Addendum No. 1

Project: Pedestrian Fencing Glenoaks Boulevard Bridge Project, Project No. 7618

SUBJECT: ADDENDUM NO. 1 – PEDESTRIAN FENCING GLENOAKS BOULEVARD BRIDGE PROJECT, PROJECT NO. 7618

CONCRETE RIBBON DETAIL

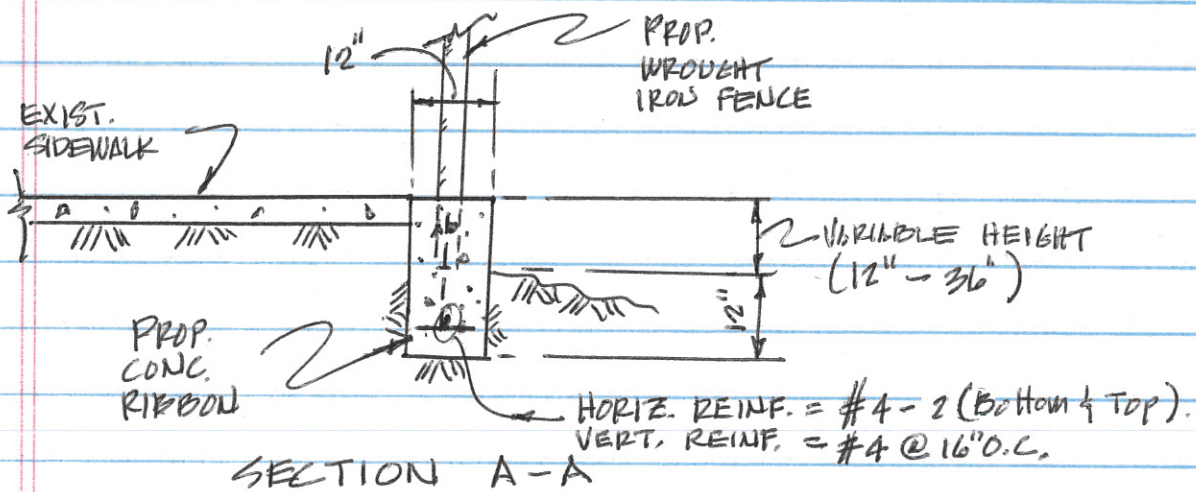
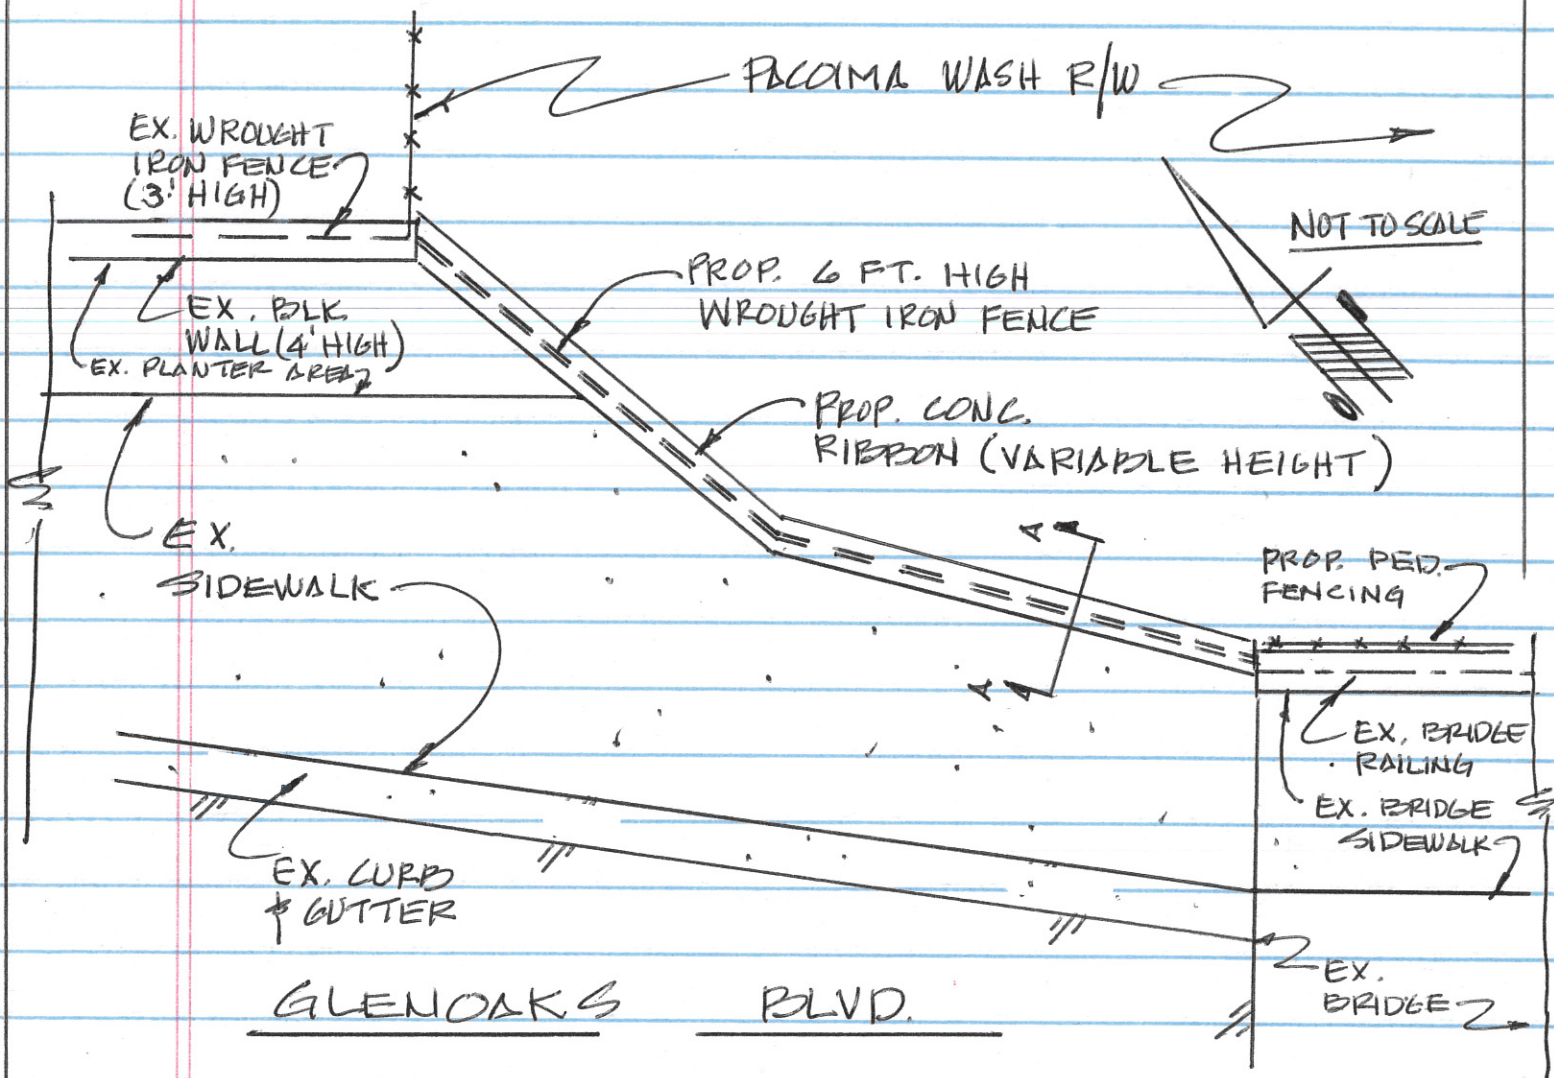
5. Appendices
 - a. Add Appendix 4, Concrete Ribbon Detail
 - b. Add Appendix 5, Tubular Steel Fence Detail
6. Revised Engineer's Estimate. New Total = \$146,000.00

Construction of PCC ribbon shall be per Appendix 4, including removal of existing chain link fence, fence posts, footings, excavation, backfill, compaction, forming, pouring, and backfill around new PCC ribbon.
